**BOARD OF ZONING ADJUSTMENT  
STAFF REPORT**

5725

Zion Baptist Church

**VARIANCE REQUEST**

# SITE PLAN

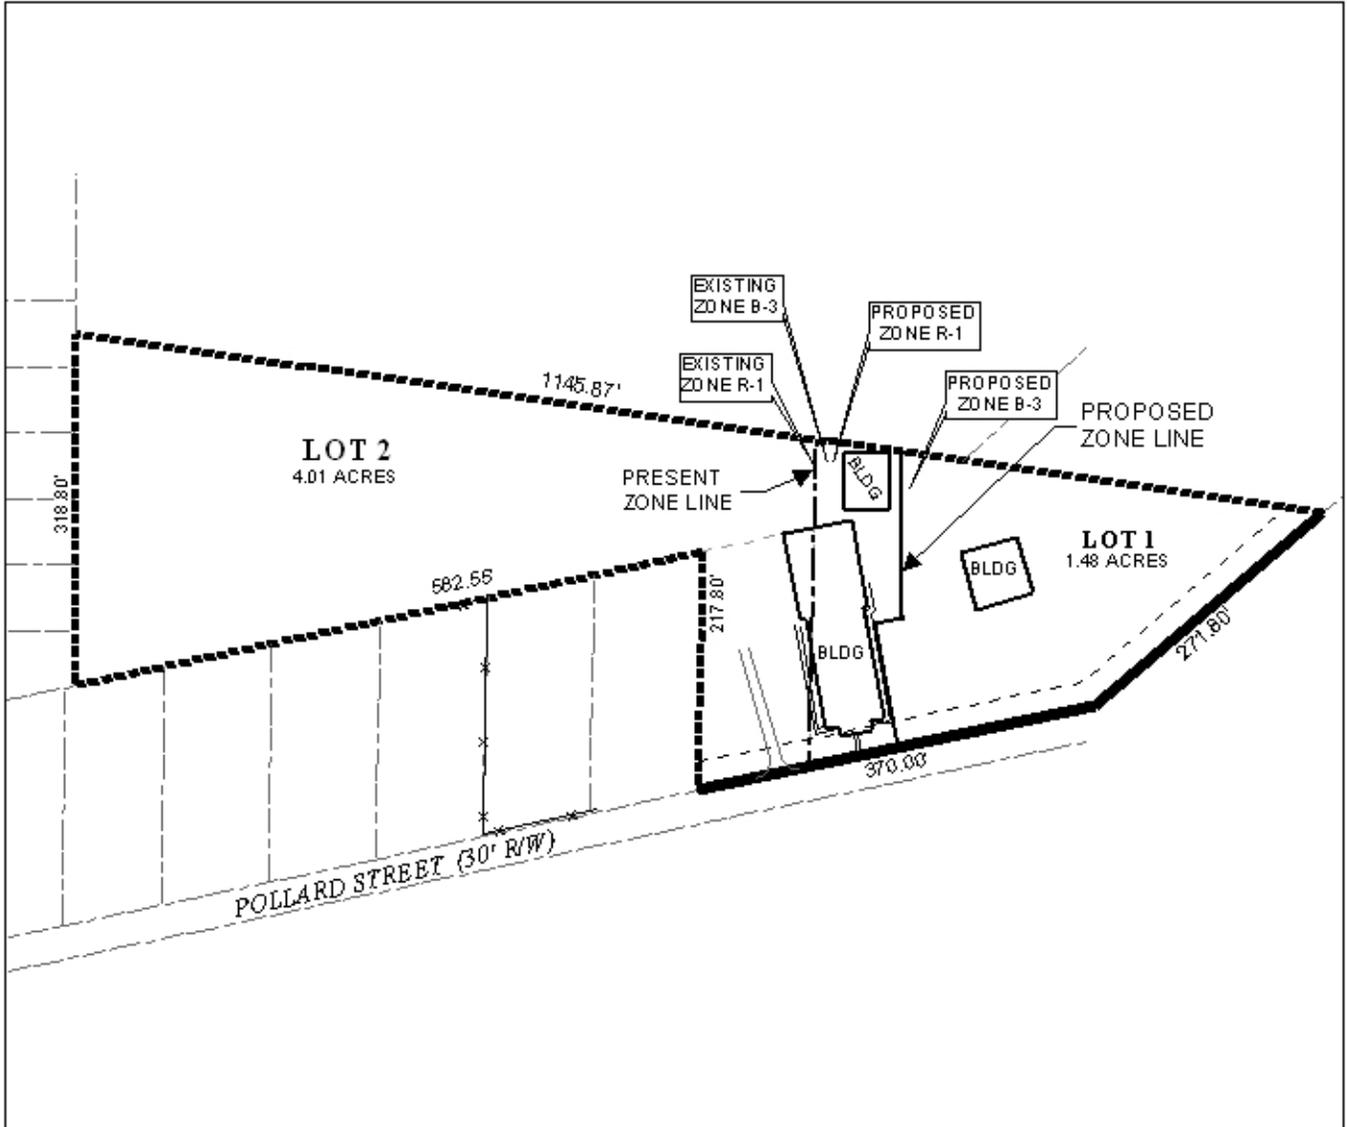
The site plan needs to be revised to indicate where the parking area currently is that is the subject of the Surfacing and Parking Ratio Variance requests. The revised site plan should also take into consideration concerns of the Planning Commission reports such as required street frontage dedication and adjusted 25' minimum building setback line, lighting, buffering and the provision of dumpster facilities. Also, landscaping and tree plantings should be shown along with the appropriate calculations. If other non-compliance beside the surfacing, access and maneuvering, and parking ratio are indicated on the revised site plan, this application should be revised to include such as variance requests with revised request fees and mail-out notification fees.

Finally, it should be pointed out that the Americans with Disabilities Act may require the provision of wheelchair accessible parking, which may consequently require some paving. The design professional should verify ADA parking requirements and revise the site plan accordingly.

- 2) revision of the site plan to illustrate which area the Surfacing and Parking Ratio Variance requests pertain;
- 3) revision of the site plan to take into consideration concerns of the Planning Commission reports such as required street frontage dedication and adjusted 25' minimum building setback line, lighting, buffering and the provision of dumpster facilities;

- 6) revision of the site plan to comply with any parking requirements of the Americans with Disabilities Act.
